How to update T26SZ

T26SZ(PRO) SOFTWARE UPDATE CHANGES

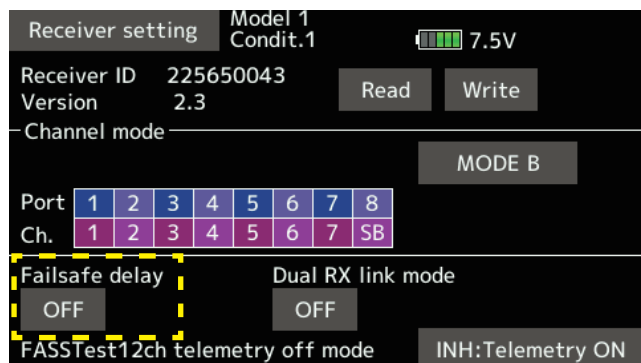
1. Failsafe Delay function newly added.

By connecting a receiver that supports the failsafe delay function, can turn the fail-safe delay function ON/OFF.

This function enables the servo movement softly toward the preset failsafe position when the failsafe activated.

4. Select ON/OFF for the Failsafe delay function.

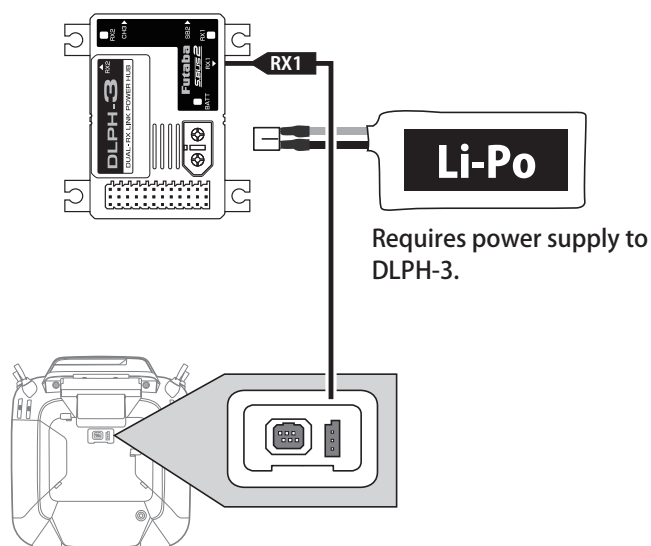
Added Vector Nozzle function for jet models.

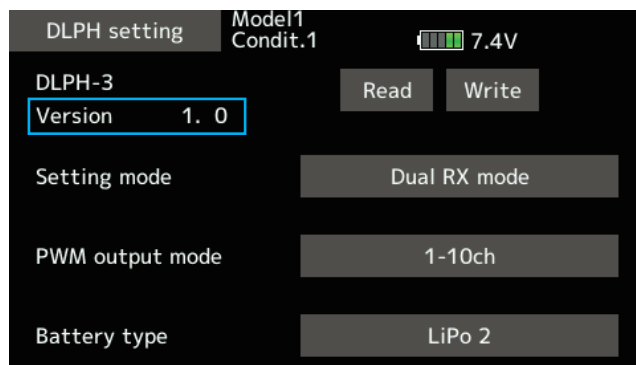
- ③ Tap [Read].

④ The version of the connected DLPH-3 is displayed.

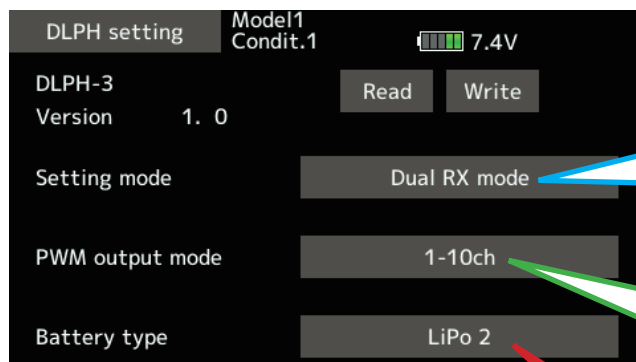
⑤ Set the mode of the DLPH-3.

Tapping the Setting mode switches as follows:

[Dual Rx mode] → [Single Rx mode] →
[Airplane Gyro] → [Dual Rx mode] → ...

Tapping the PWM output mode switches as follows:

[1-10ch] → [11-20ch] → [21-24ch] → [1-10ch] → ...

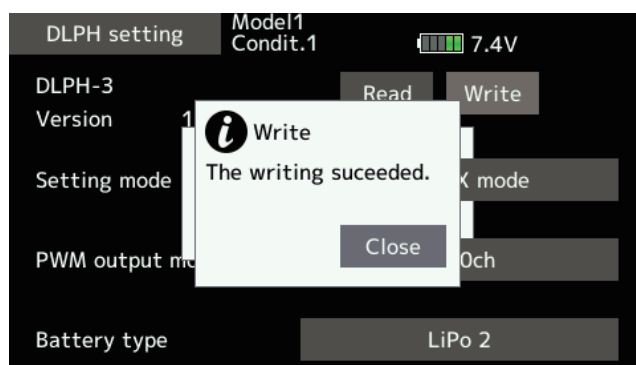
⑥ Tap Write, a confirmation screen will appear. Tap "Yes" to write the settings to the DLPH-3.

If writing fails, the above message will be displayed. Check the connection.
